ADDENDUM NO. 1

Additions & Renovations to Pleasant Run Elementary School
1800 North Franklin Road
Indianapolis, IN 46219

PROJECT: PLEASANT RUN ELEMENTARY SCHOOL RENOVATION & ADDITION

PROJECT NO: 2020061

DRAWING NUMBER
S301

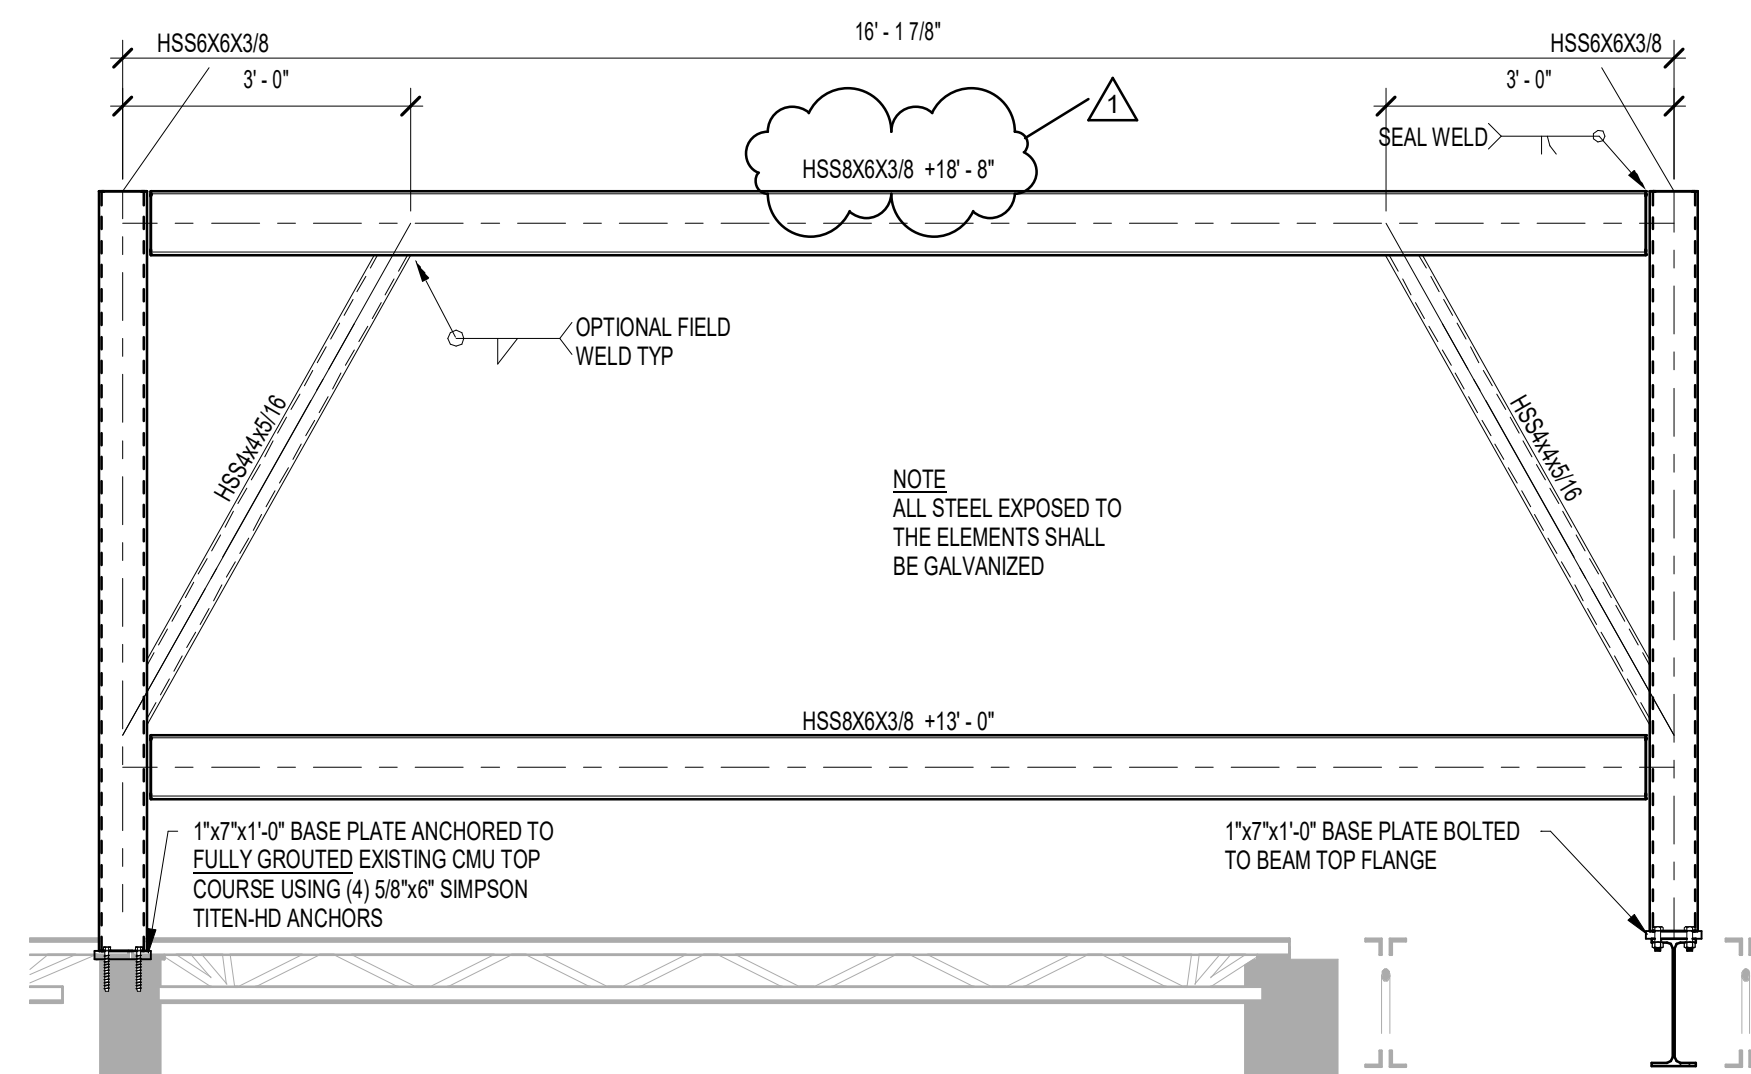
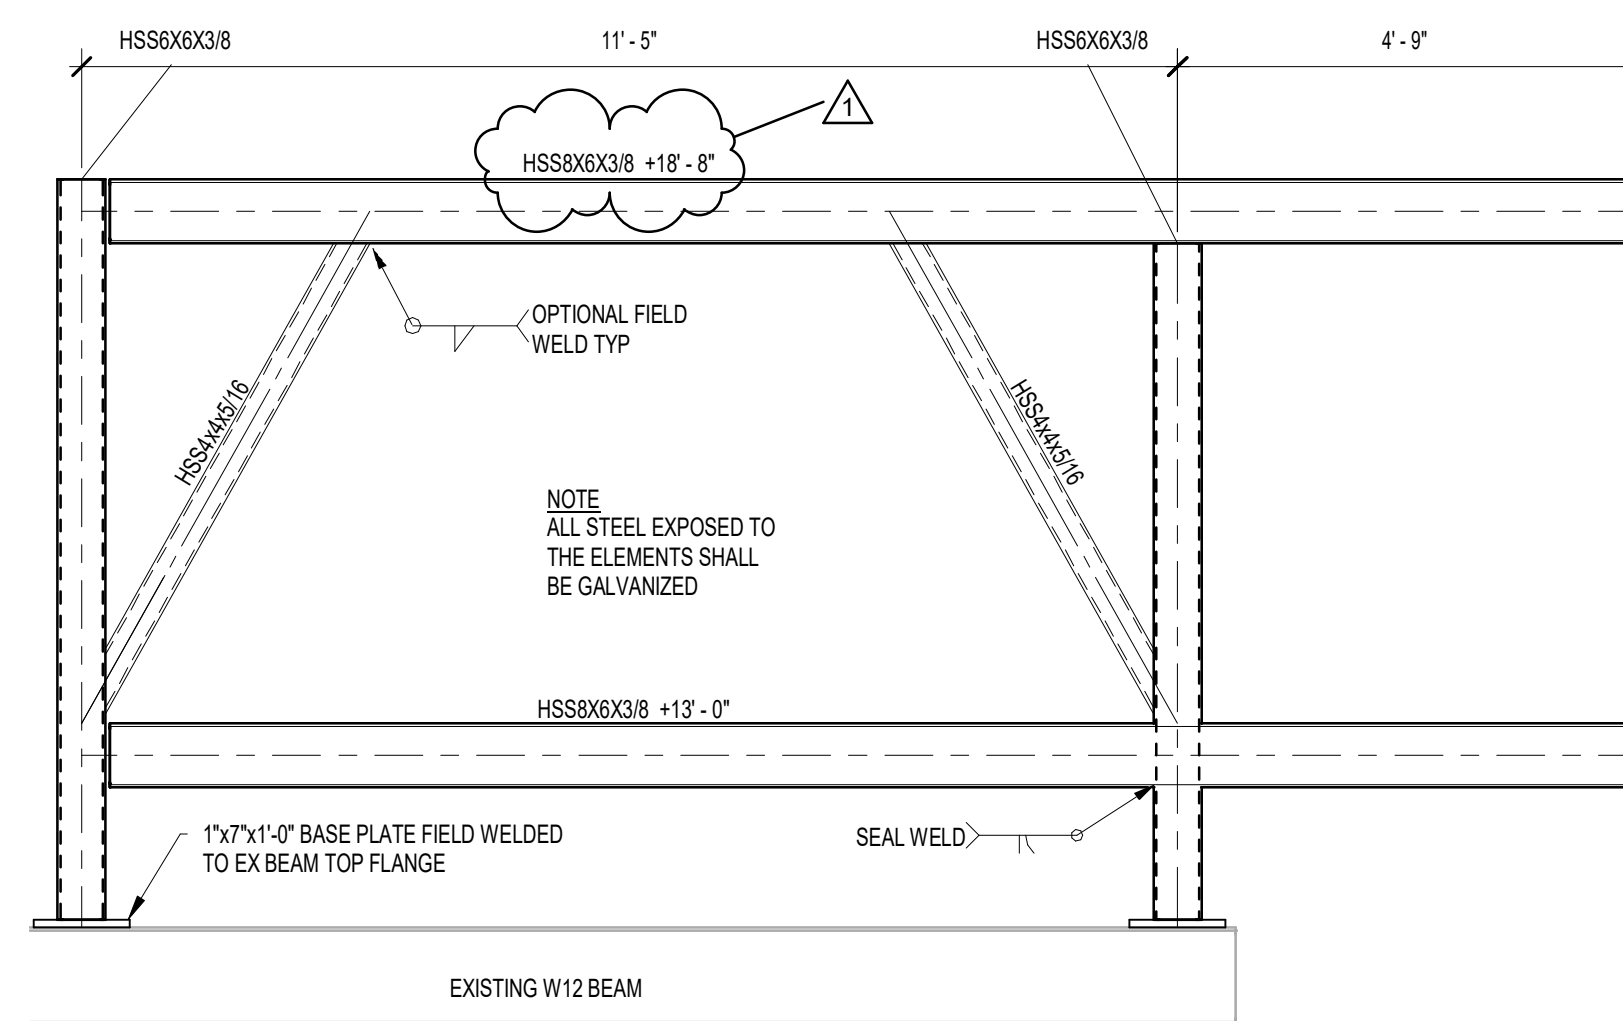
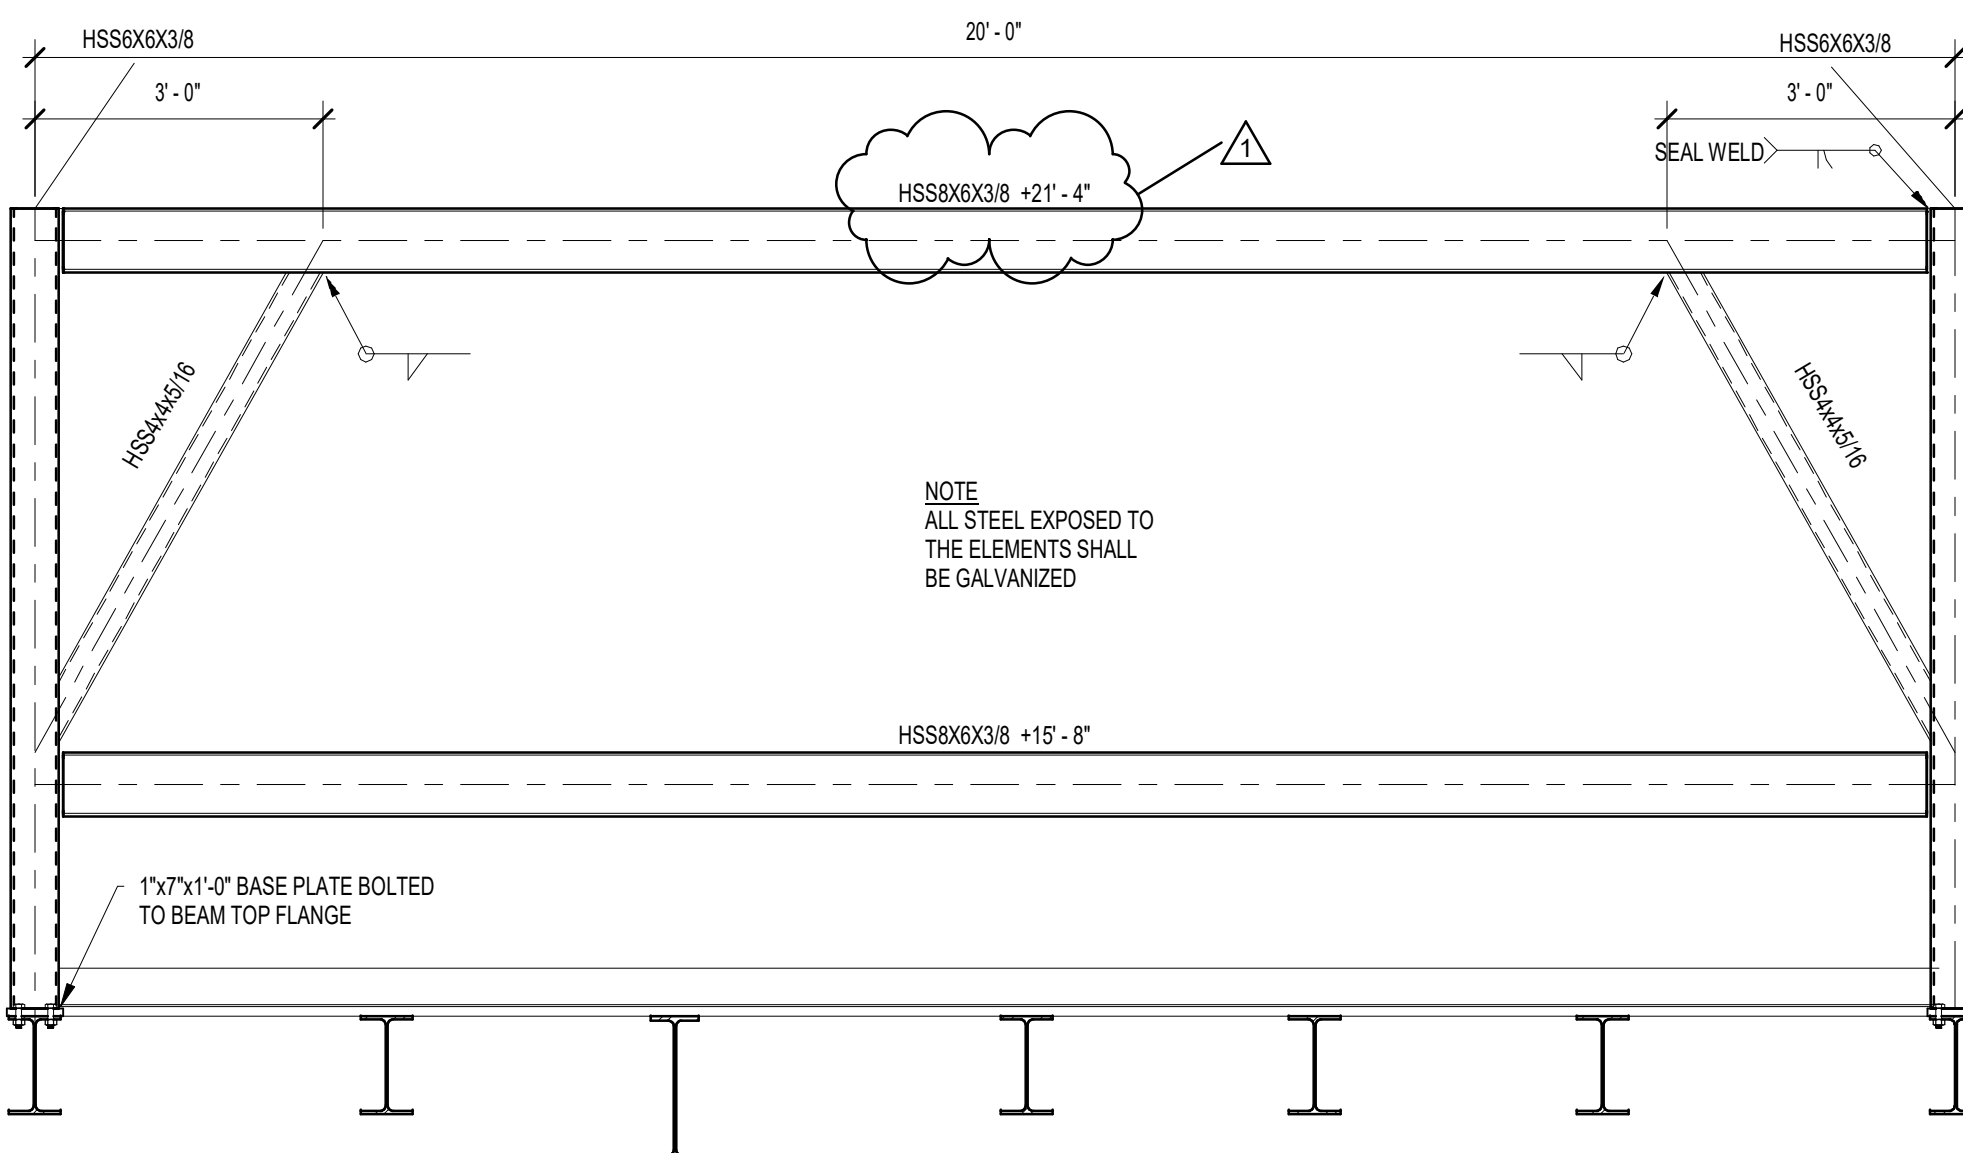
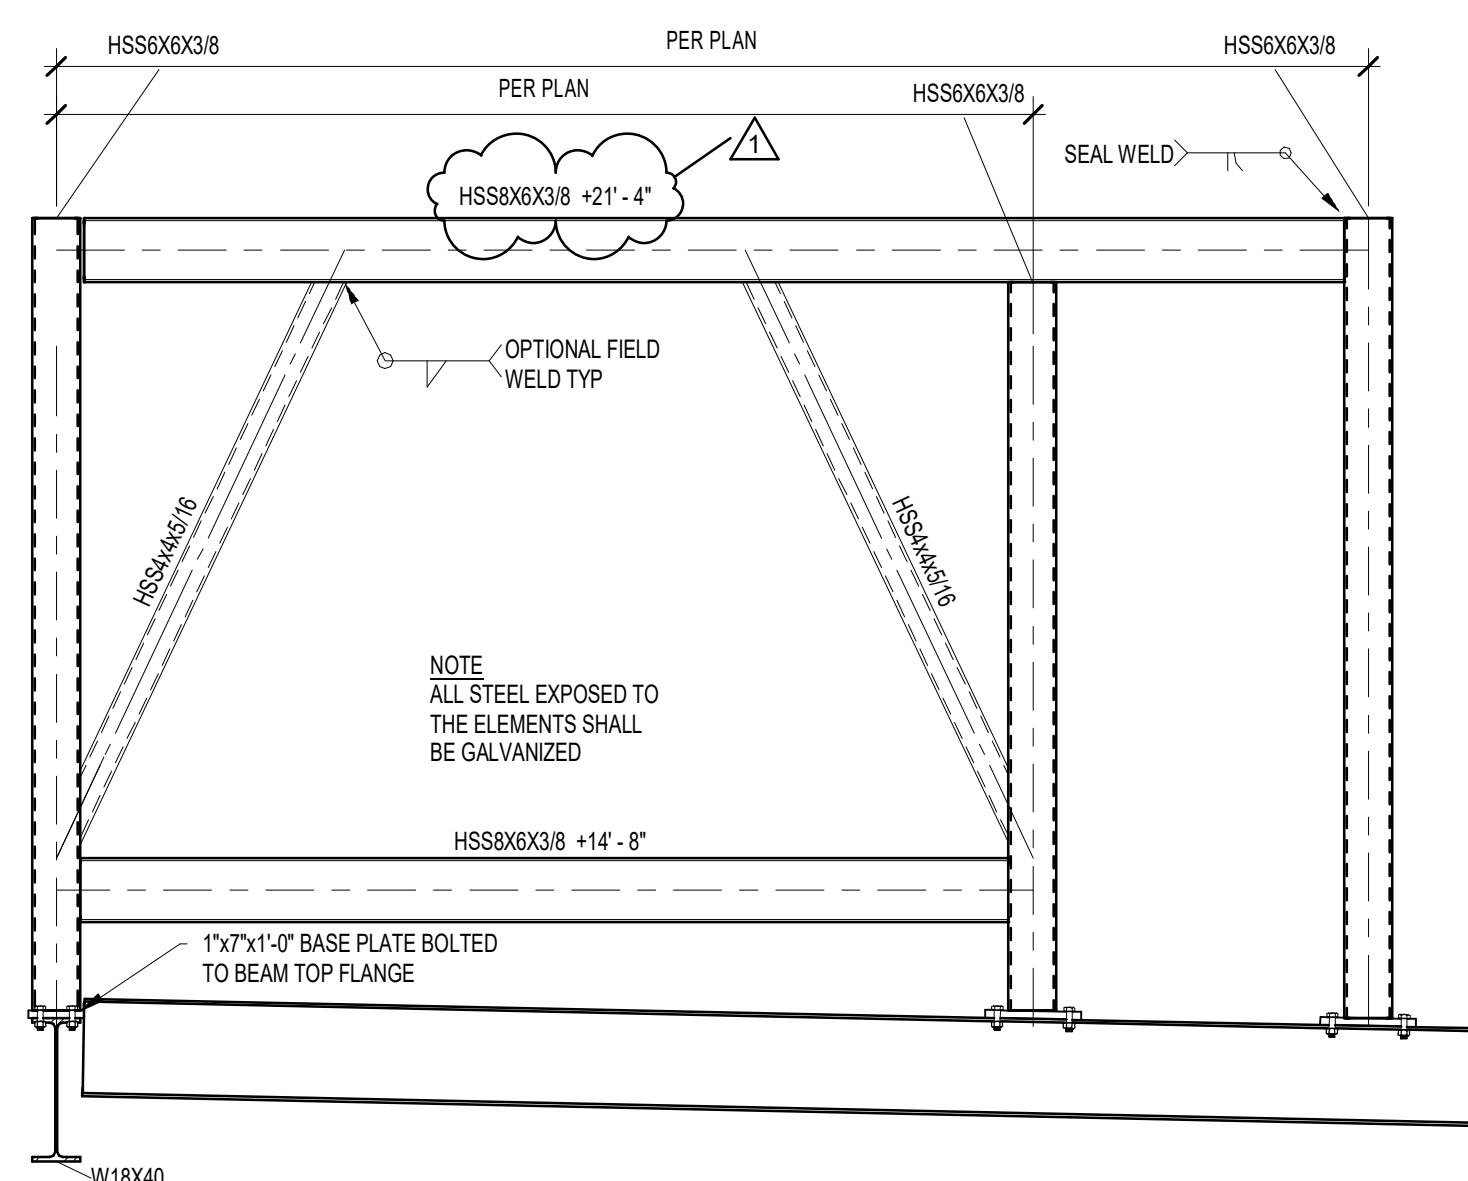
Drawing S301 Braced Frame Elevations

1. Show the modified dimensions and details of screen walls.
